FAIRFAX COUNTY

STAFF REPORT ADDENDUM II

APPLICATION RZ/FDP 2004-PR-044

APPLICANT: Tysons Corner Holdings LLC and Tysons Corner Property Holdings LLC

① PHASE TWO:
 PLAN VIEWS

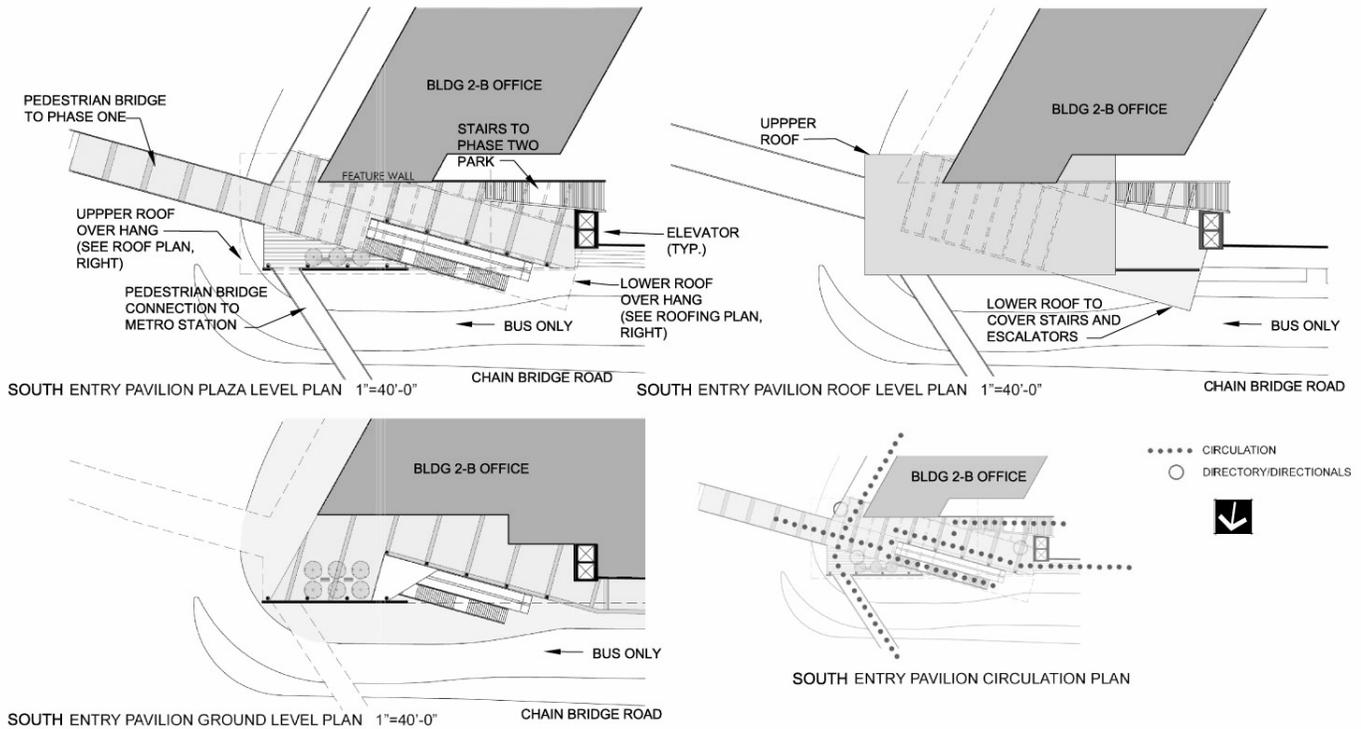
The elevators at the western end of the transit pavilion provide access to all three pedestrian levels associated with this portion of the site; the bus plaza at elevation 450 feet, the main pedestrian level associated with second level of the mall, elevation 467, which is also the elevation of the bridge across Chain Bridge Road, the bridge to Phase 1 and its plazas and the path to the mall along the office building; and, the Phase 2 plaza at elevation 489 feet. The revised design ensures that a pedestrian crossing Chain Bridge Road on the bridge from the future Metrorail station will be able to see the stair/escalator connections to the Phase 2 plaza and to the bus plaza, as illustrated below.

The design clearly demonstrates that the vertical circulation between the bus plaza, the main pedestrian level and the Phase 2 plaza which is located above the main pedestrian level is accommodated via elevators located at the western end of the pavilion building, the stairs and escalators between the main pedestrian level and the bus plaza, and stairs to the Phase 2 plaza. Accessible access to the Phase 2 plaza is provided via the elevators in the office building and via the cantilevered path to the western end of Phase 2.

② PHASE TWO:
SOUTH ENTRANCE PAVILION FROM CHAIN BRIDGE ROAD ELEVATION

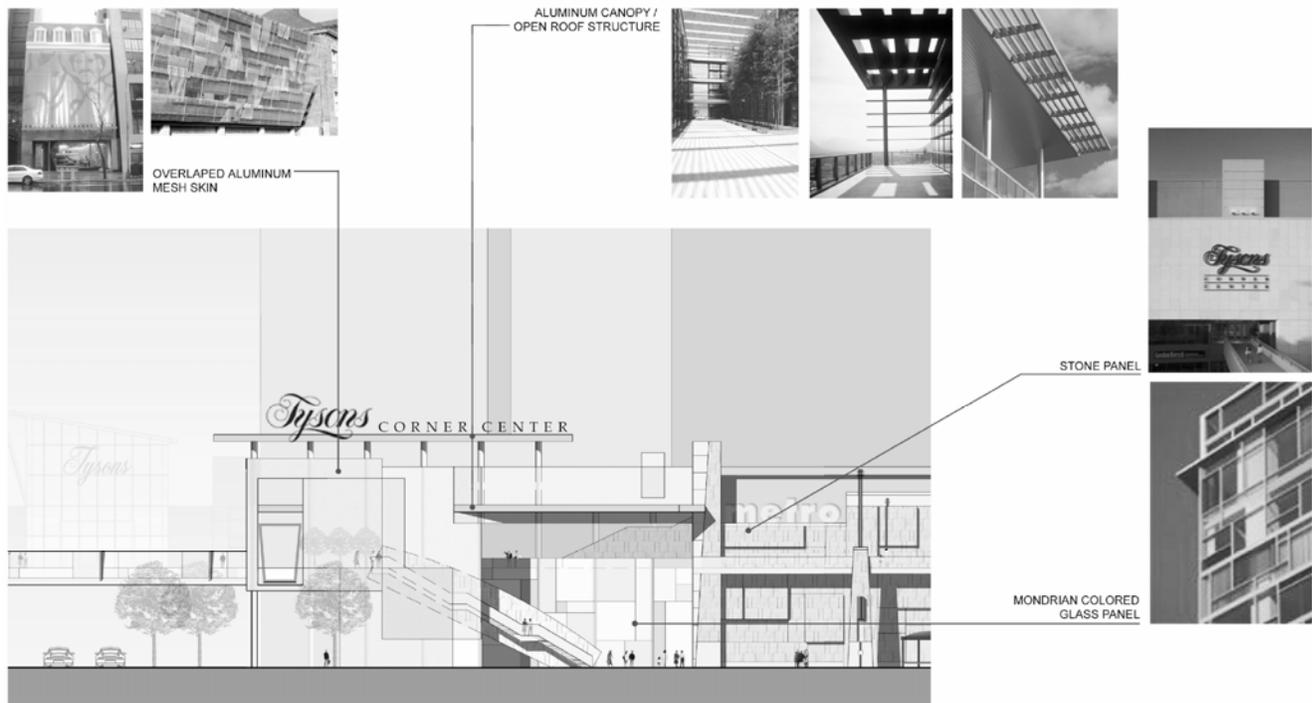
The portion of the vertical face of the parking garage that is devoted to the transit pavilion has been expanded to extend approximately the width of the face of Building 2A facing this road and is now clearly divided between the transit pavilion and the rest of that façade which is located above the bus plaza. This visual distinction is provided by differing architectural treatments. The pavilion building is faced with metallic panels and topped with two roof structures consisting of two narrow horizontal planes. One roof structure is located at the top of the pavilion building and the second lower roof covers the stairs and escalator to the bus plaza. The area under the lower roof is in front of a wall comprised of rectangular colored panels located below the main pedestrian level that vary in size and resemble a piece of abstract art. This element provides the backdrop for the stairs and escalator between the bus plaza and the main pedestrian level, and is on the same general vertical plane as the garage wall. The architecture of the garage and the pavilion is also linked by the design of the garage wall, which includes stone facing that is also divided into panels. The stone panels on

the garage are differentiated by placing the panels on protruding vertical planes that create shadows and a feeling of depth. (See the illustration under Bus Plaza below.)

As described in the memorandum from the consultant, the revised layout of transit pavilion addresses their original concerns regarding the design included in the previous CDP/FDPs as described above.

② PHASE TWO:
MALL ENTRANCE WITH WATER FEATURE AND TRANSIT PLAZA FROM CHAIN BRIDGE ROAD AT
STREET LEVEL

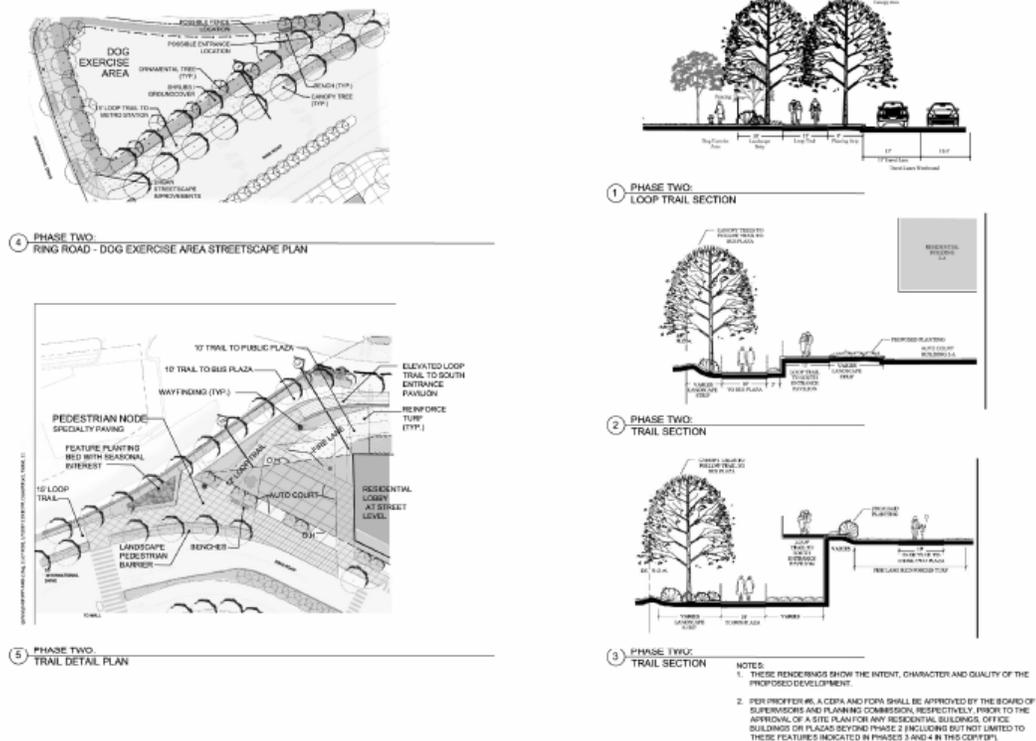
The revised CDP/FDP does not include a roof on the bridge between Phases 1 and 2 to protect pedestrians from inclement weather. Staff concurs with the consultant's comment that a roof should be considered. In lieu of the roof, the revised

design includes a glass screening wall on the northern side of the bridge to protect pedestrians from northern winds during the winter. The applicant is concerned that having a roof or other structure would make the bridge too substantial in appearance and be contrary to the design of the enhanced entrance area, which includes the proposed waterfall fountain. However, it should be noted that both the draft proffers and the CDP/FDP note that a roof on this bridge is an option and that the design of this bridge is one of the elements proffered to be reviewed by the Planning Commission. Staff feels that the design of the bridge could be modified to better integrate it with the project and that the bridge could be an entry or gateway element, in lieu of the applicant's desire to limit its impact. These elements could be considered as part of the Planning Commission's review of the architecture of the bridge pursuant to the proffers.
